REQUEST FOR INFORMATION (RFI)

RFI No.: 4 **RFI Date:** 10/25/2016

Project Name: Newberg Villa Road Improvements, Haworth to Crestview, Phase 1 Culvert Replacements

Subject: Clarification Regarding Handrail

GROUT LEVELLING

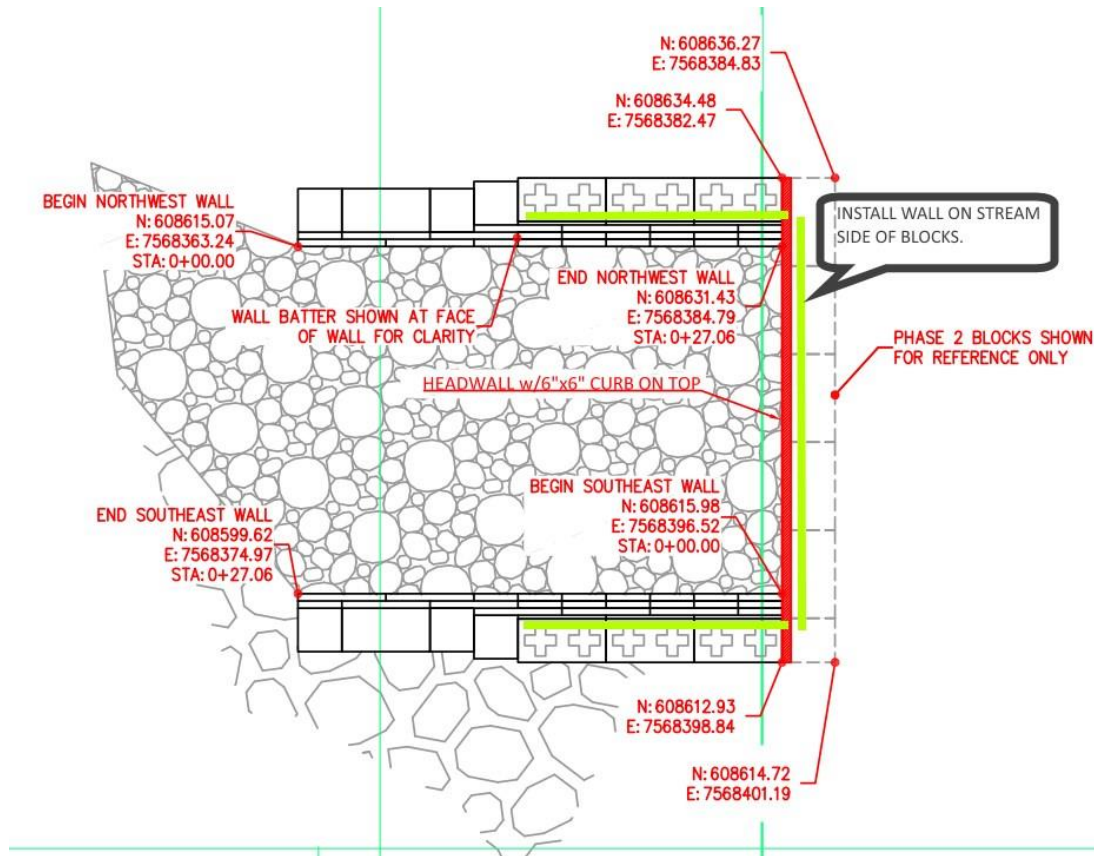
First, it is to be noted that due to each block having a different slope on the northeast side of Culvert B, the base plate for the straight railing may not have full bearing all the way around.

- 1) In response to the first question regarding each block having different slopes, please provide a grout leveling pad (see image for concept), or level the base plate with washers. If using washers, use same type of metal for the washers to prevent corrosion.

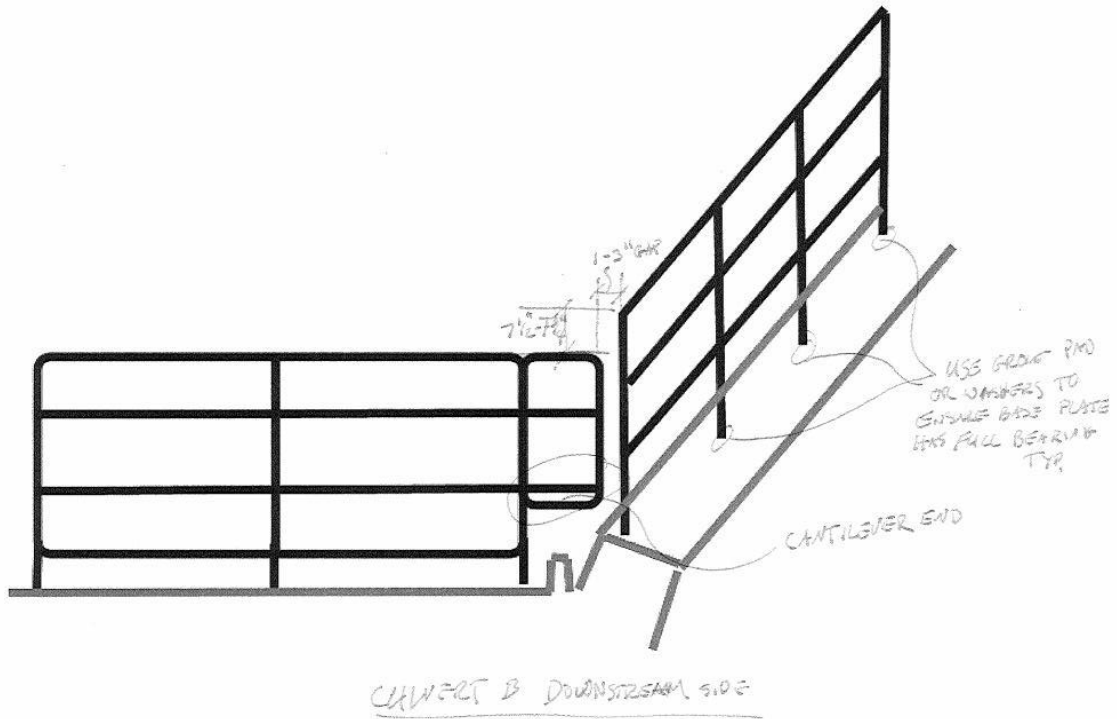
Second, the southwest side of Culvert B, having the same conditions mentioned above, and the blocks parallel with the road are 7- 1/2 to 7-3/4 inches higher than the legs. This means that if the rail on the road side is installed at 34" the rail on the wing walls would be 42" high. Additionally it is noted the rail is to be sleeved together, meaning the height of the rail would be uniform throughout. If the rail is installed at the same height there will be a 7"+ larger gap between the bottom of the last run of the rail and the top of the wing walls.

- 2) To resolve the issue regarding the elevations of the wall on the downstream side of culvert B, the hand rails may be treated as three separate sections independently, and the design of those rails shall meet the specifications of the project. The legs of the block wall railing shall cantilever to extend over the gap at the angle point where the sections will meet. Leave a gap less than 3" at the location where the sections meet. The railing is to be installed on the stream side of the blocks. See image below for more detail. These sketches are not to scale and are for conceptual purposes only.
